Access Compliance Report

Public Rights-of-Way

(Curb Ramps)

Intersection ID: 27369	Main Street: JORDAN_RAE_LN	Cross Street: MEADOW_RUN_LN	Location: NE
ADA ID: 24485C589DA7	Ramp Type: BlendTrans2	Initial Pass/Fail: Fail	Overall Compliance: No
		Severity Score: 8.75

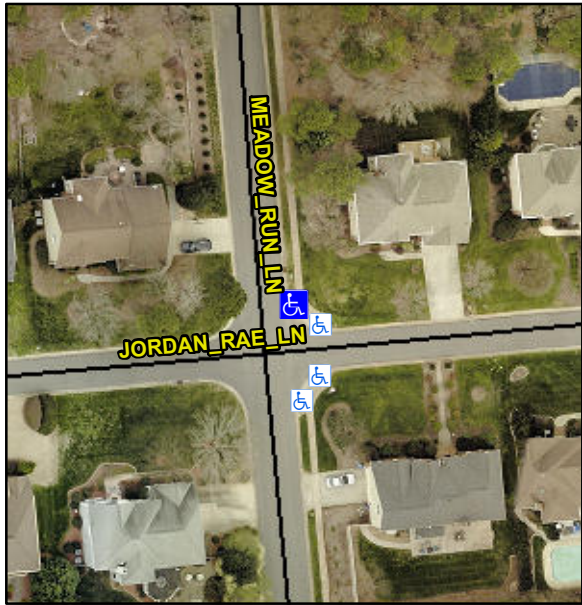
Codes/Mitigation Info/Possible Solution			Field Measurements/Component Compliance						
	Possible Solutions:		Compliance	Description	Data	Compliance	Description	Data	
	Remove & Replace Curb Ramp With Two New Directional Ramps or Equivalent.		N/A	Ramp Length (in)	96.0	Yes	BlendTrans Slope (%)	3.8	
			No	Ramp Width (in)	39.0	Yes	BlendTrans XSlope (%)	1.2	
			N/A	Flare Type LT	N/A	N/A	Flare Type RT	N/A	
			N/A	Flare Slope LT (%)	N/A	N/A	Flare Slope RT (%)	N/A	
			N/A	Flare Traversable LT?	N/A	N/A	Flare Traversable RT?	N/A	
			N/A	Landing Length (in)	N/A	N/A	DWS Provided?	N/A	
			N/A	Landing Width (in)	N/A	N/A	DWS Contrast?	N/A	
			N/A	Landing Slope (%)	N/A	N/A	DWS Length (in)	N/A	
			N/A	Landing X Slope (%)	N/A	N/A	DWS Full Width?	N/A	
Street 1 Name	MEADOW RUN LN		N/A	Landing Curb? (Y/N)	N/A	N/A	DWS Offset (in)	N/A	
	Stop Condition-Street 1		None	N/A	Shared Landing?	N/A			
	Street 2 Name		N/A	N/A	Gutter Ponding?	N/A	N/A	Gutter Slope (%)	N/A

Stop Condition-Street 2		N/A	N/A	N/A	N/A	N/A	Gutter X Slope (%)	N/A
				N/A	Painted X Walk1?	No	N/A	Painted X Walk2?	N/A
					X Walk 1 Direction	To W		X Walk 2 Direction	N/A
					X Walk 1 Width (in)	N/A		X Walk 2 Width (in)	N/A
					X Walk 1 Slope (%)	4.6		X Walk 2 Slope (%)	N/A
					X Walk 1 X Slope (%)	0.1		X Walk 2 X Slope (%)	N/A
				N/A	Ramp inside XWalk1?	N/A	N/A	Ramp inside XWalk2?	N/A
				Road Slope (%)	0.1		Clear Space?	N/A	
				Road X Slope (%)	4.6	N/A	Clear Space to XWalk (in)	N/A	
			N/A	Any Obstructions?	N/A	N/A	Storm Grate/Utility Hazard?	N/A	
				Obstruction Type			Storm Grate/Utility Type		
					N/A			N/A	
						Yes	Surface Condition? (G/P)	Good	
						No	Curb Slope (%)	9.4
